Item Name: AS350 / AS355 Stainless Steel Fwd Crosstube

DART AEROSPACE LTD		Work Order:	148811
Description: Crosstube High Fwd, SS (AS350/355)		Part Number:	D350-748-103
Inspection Dwg: D350-748-143 Rev: A		Page 1 of 1

DART AEROSPACE LTD HAWKESBURY, ONTARIO, CANADA	
DRAWING NO. D350-748-143	REV. A SHEET 1 OF 4
TITLE CROSSTUBE (AS 350/355 HI FWD)	SCALE NTS
COPYRIGHT © 2015 BY DART AEROSPACE LTD THIS DOCUMENT IS PRIVATE AND CONFIDENTIAL AND IS SUPPLIED ON THE EXPRESS CONDITION THAT IT IS NOT TO BE USED FOR ANY PURPOSE OR COPIED OR COMMUNICATED TO ANY OTHER PERSON WITHOUT WRITTEN PERMISSION FROM DART AEROSPACE LTD.

DRAWING NO. D350-748-143	TITLE CROSSTUBE	REV. A	DART AEROSPACE LTD ENGINEERING ORDER		D.E.O. NO. D350-748-143-A-1	SHEET NO. SHEET 1 OF 1	SCALE NTS
DRAWN <i>ap</i>	CHECKED <i>ASS</i>	MFG. APPR. <i>[Signature]</i>	APPROVED <i>[Signature]</i>		DE APPR. <i>[Signature]</i>		
DATE 15.11.18	DATE 15.11.18	DATE 16.02.19	DATE FEB 19 2016		DATE 2016.02.19

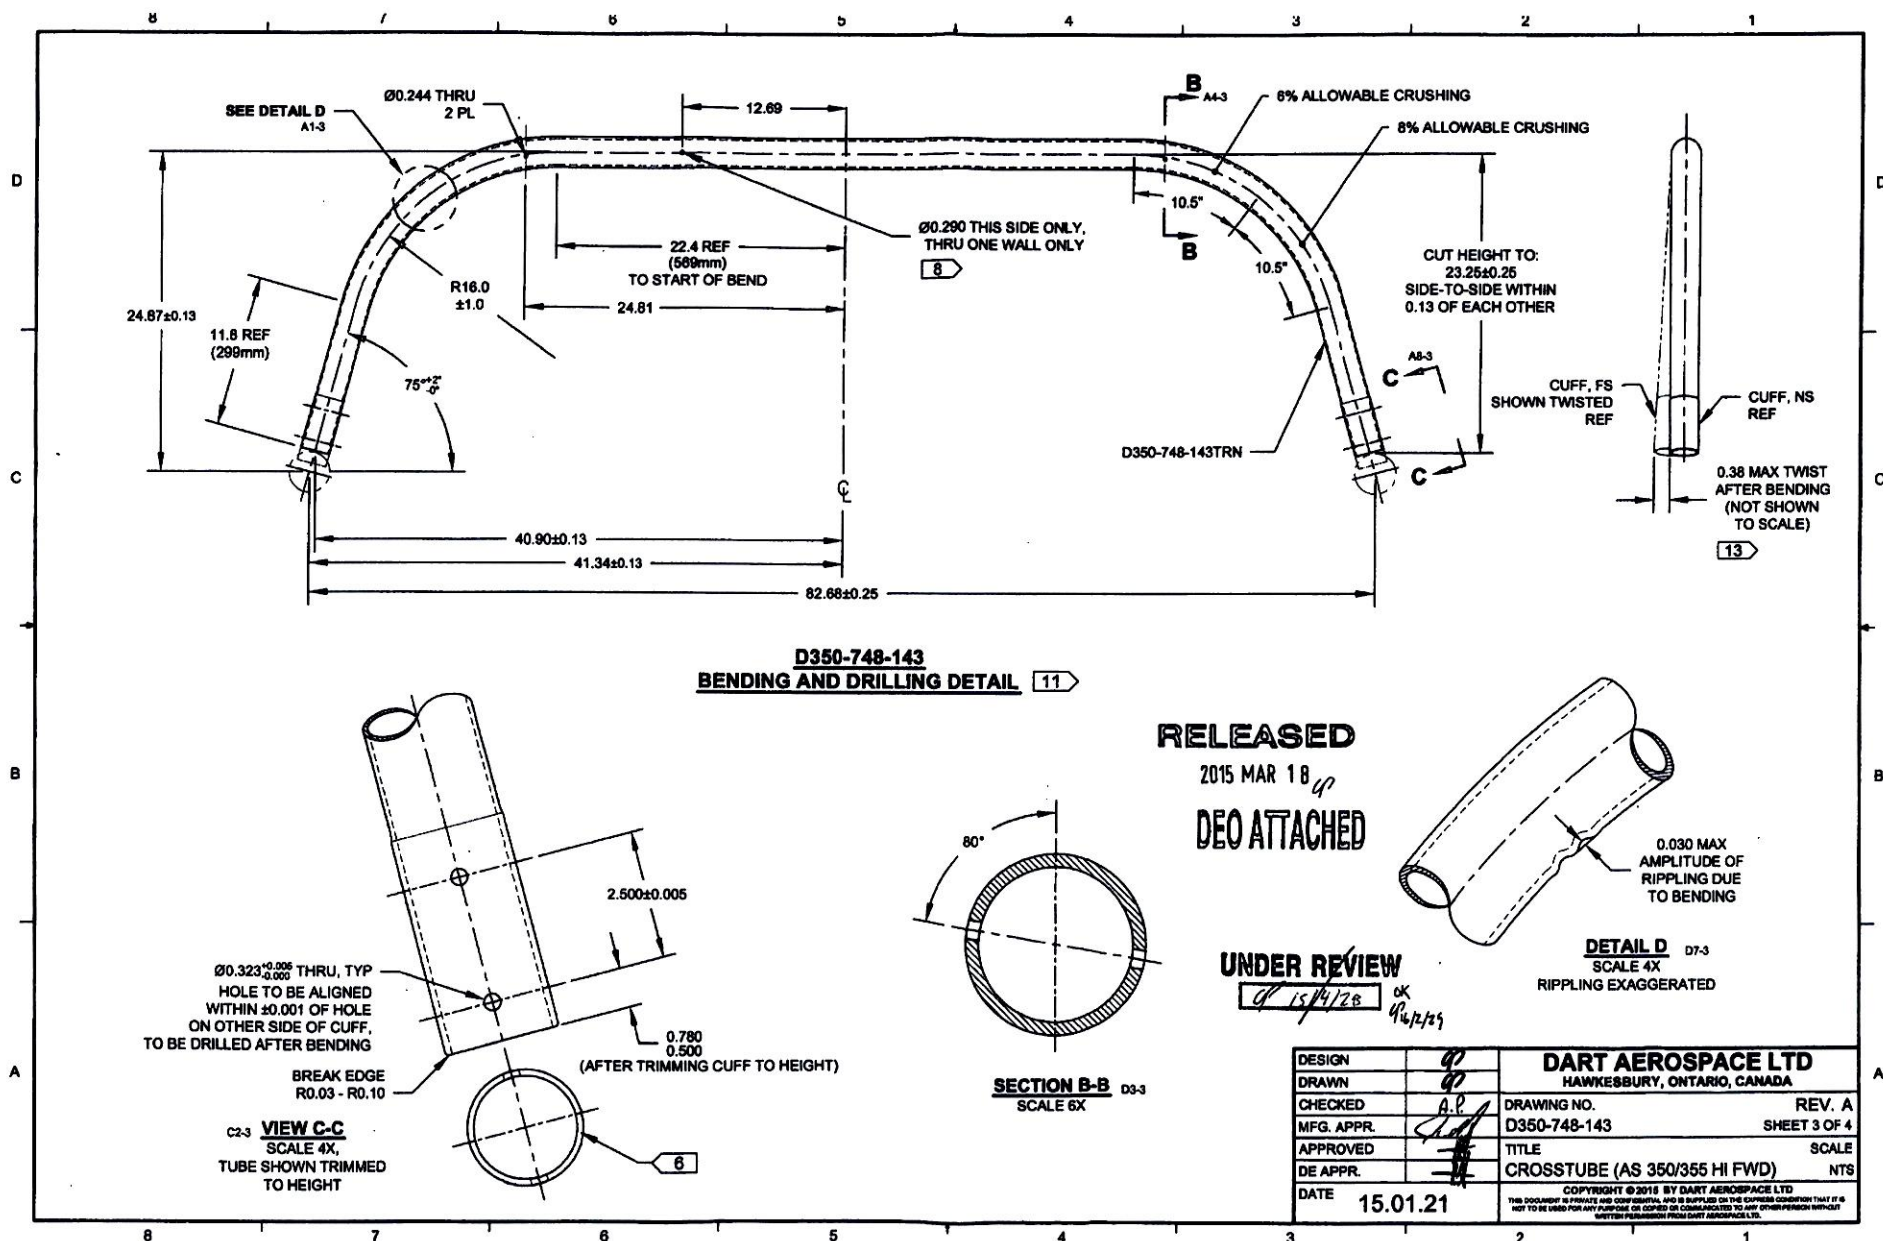
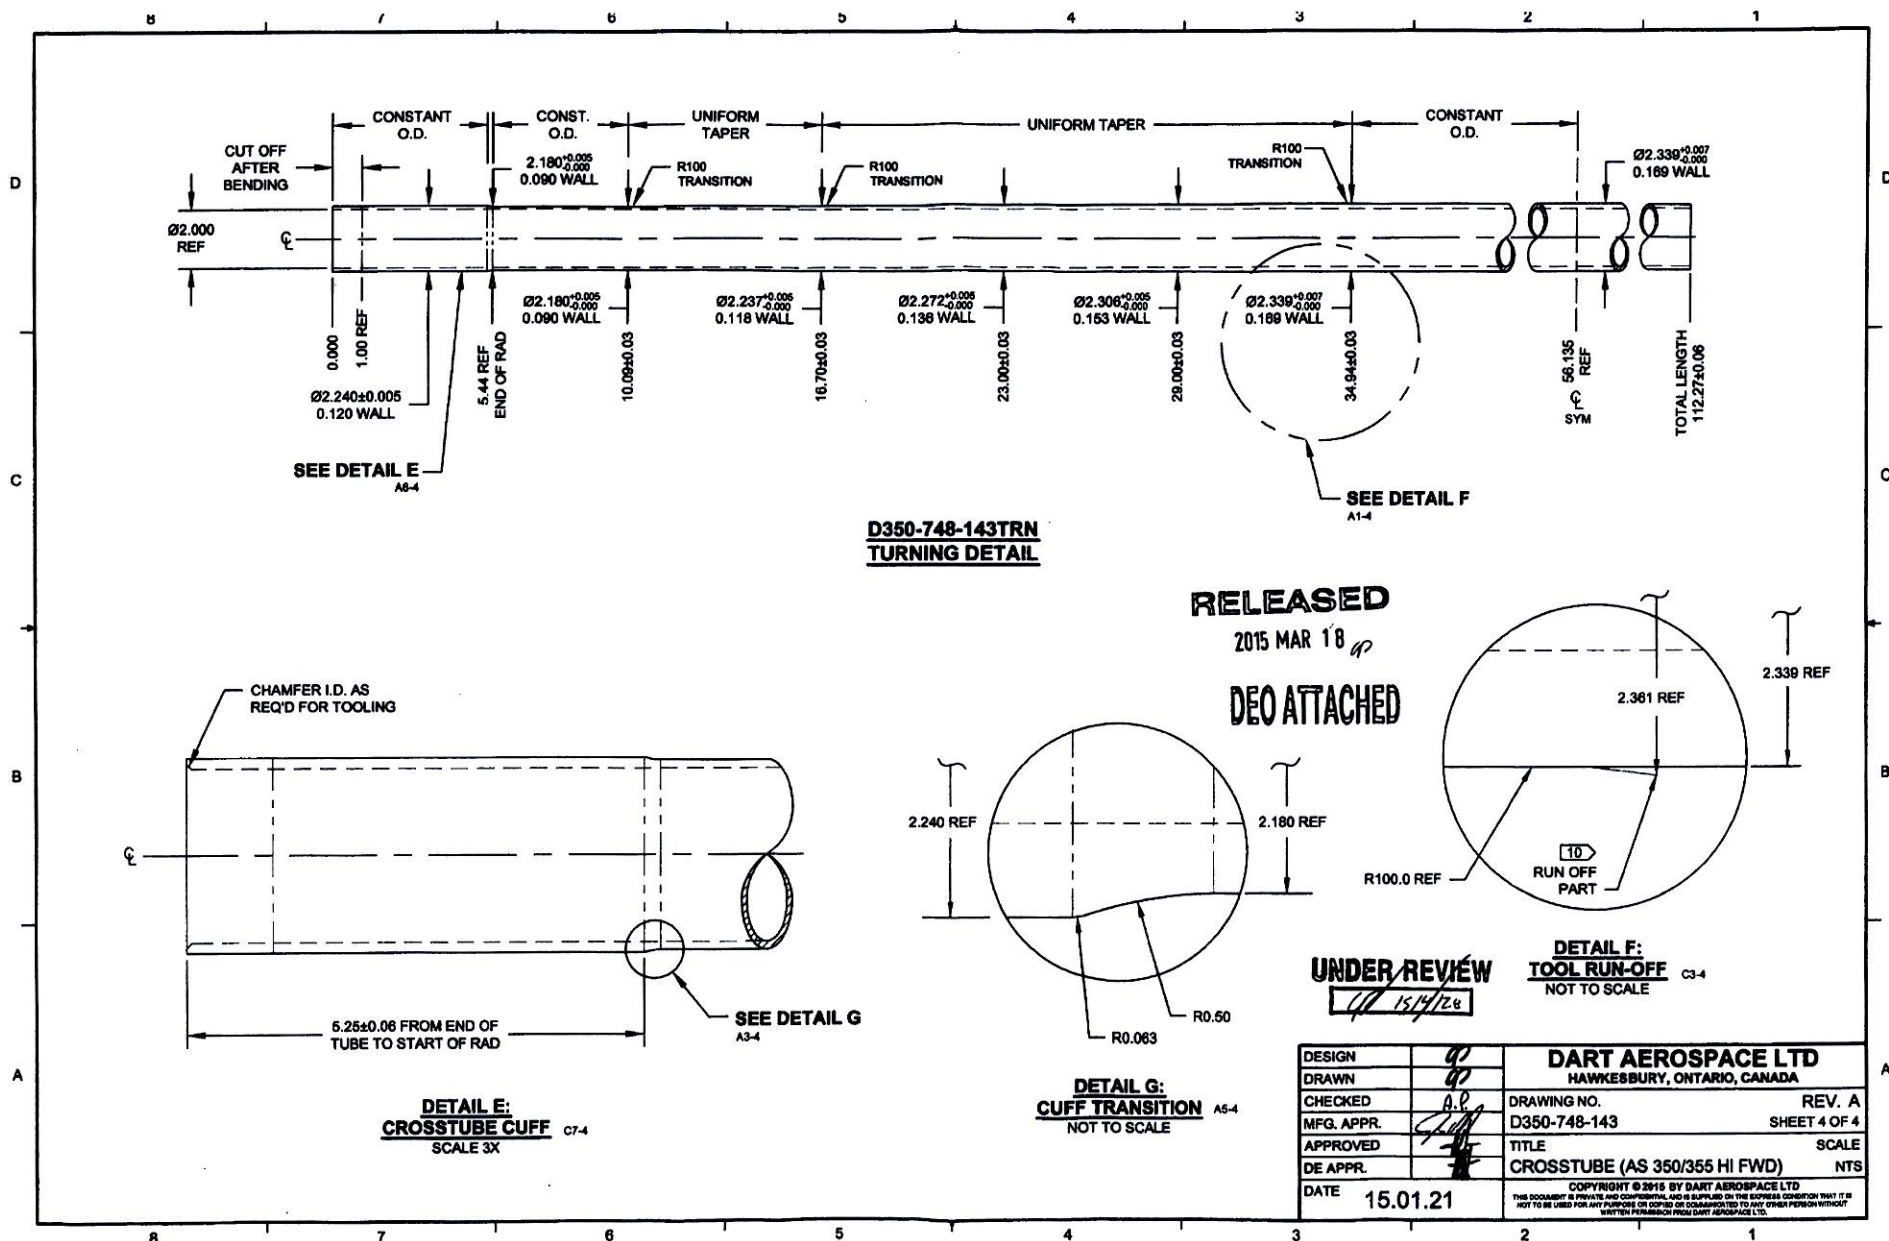
AMEND NOTE 2 (SHEET 1) AS FOLLOWS:

- 2) FINISH: PREPARE SURFACE PER DART QSI 005 4.1.4
 PRIME INSIDE AND OUTSIDE PER DART QSI 005 4.2
 PAINT OUTSIDE PER DART QSI 005 4.2
 OR
 POWDER COAT WHITE (4.3.5.2) PER DART QSI 005 4.3
